The Corporation of the District of Saanich

Report

To: Mayor and Council
From: Sharon Hvozdzanski, Director of Planning
Date: February 28, 2018
Subject: Rezoning and Development Permit Application
File: REZ00592 DPR00690 • 2707 Richmond Road and 1810 Kings Road

Figure 2: Site Plan

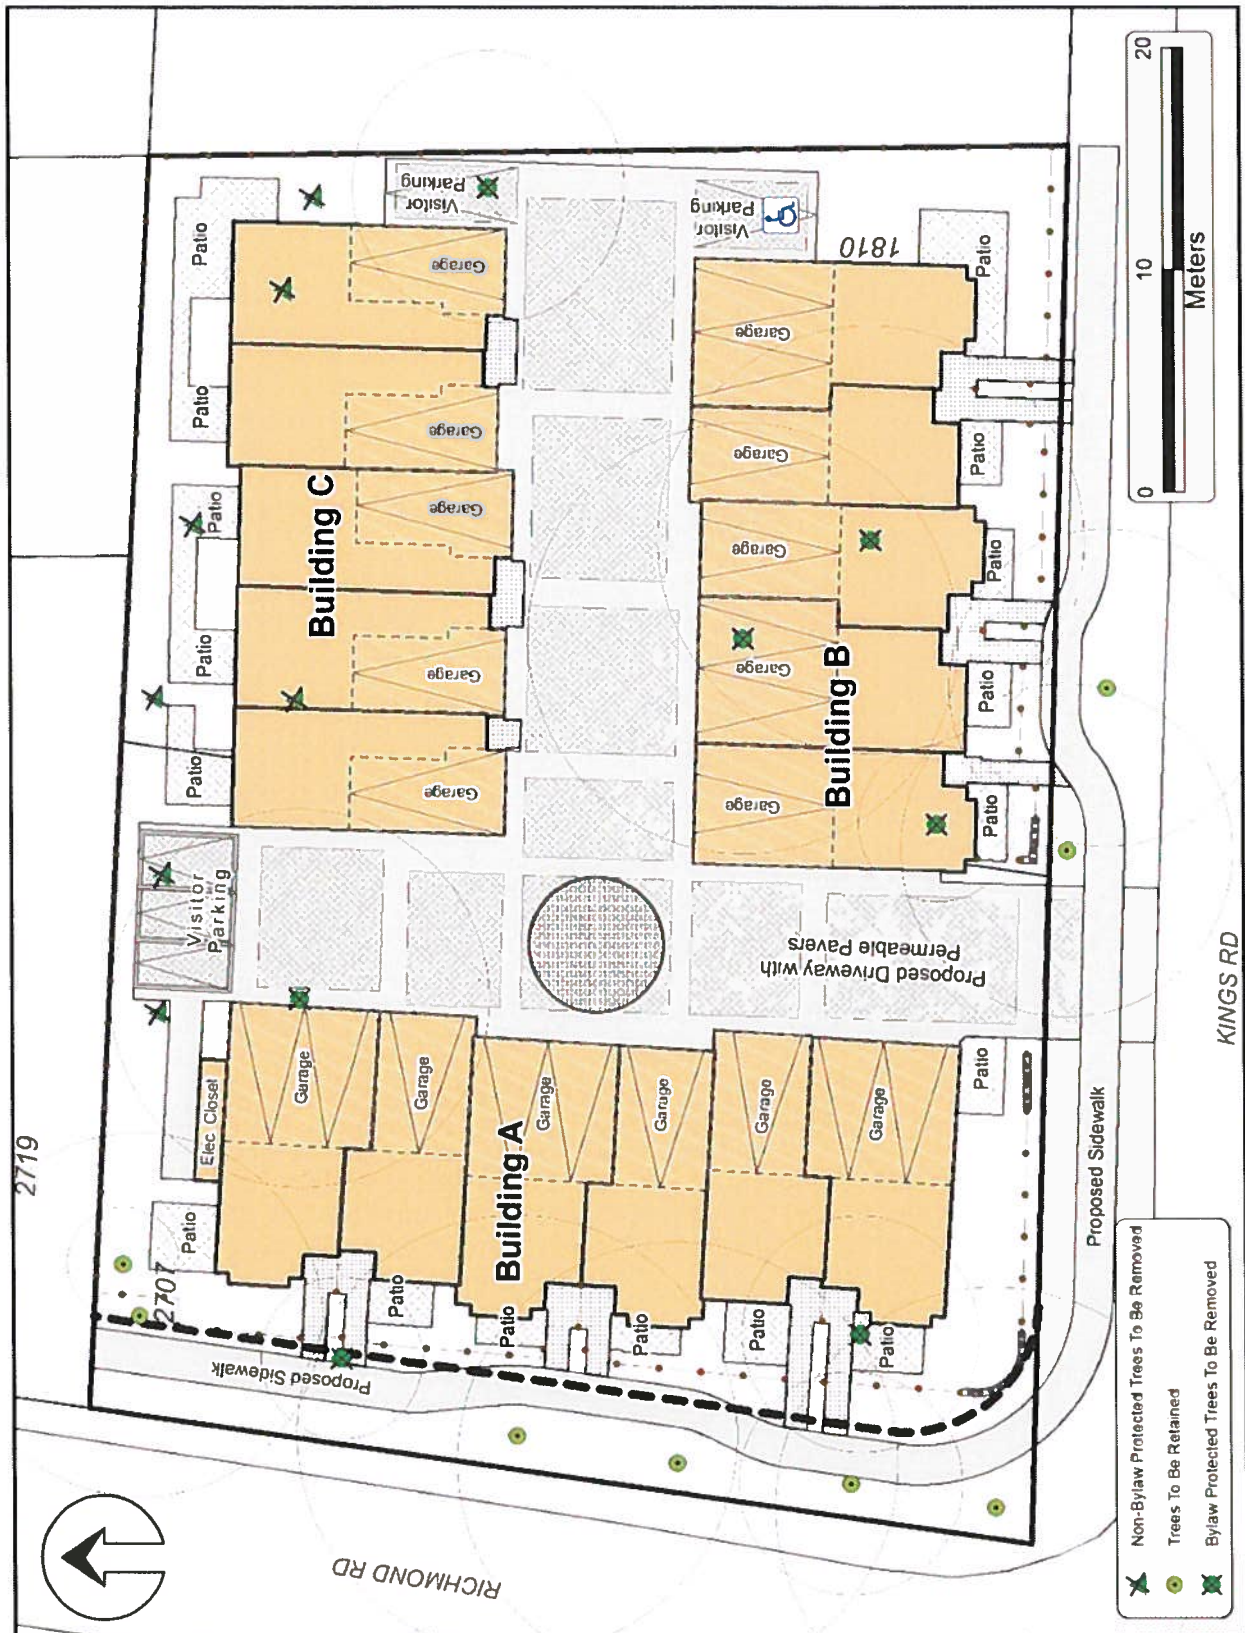
- The accessible parking offered does not have any cover. Applicant should consider that many buyers are aging and have mobility issues.
- This will compliment other developments up the street and is nicely set back. Maneuvering vehicles on-site could be impacted if everyone leaves at the same time.

- Applicant should consider liability insurance in case someone is injured on the sidewalk where a statutory right-of-way is used.
- The project compliments the streetscape and area. Consider building in disability parking for visitors.

- Question raised as to why the individual entrances are not different/separated from one another. Suggestion that they could have made entrances at the end of Building A more special by having corner entrances.

- The site is challenging and the applicant did a good job of addressing issues with setbacks and the bump out. The east setback is fairly tight but the vegetation will help as will the additional fence height.

- Frontages look good but suggestion made to try and soften the entrances on Building C, which has garage doors beside the main entrances.
- Design is good. Suggestion to consider putting a dormer on the Kings Road roof.

No design changes were made in response to the Panel's comments.
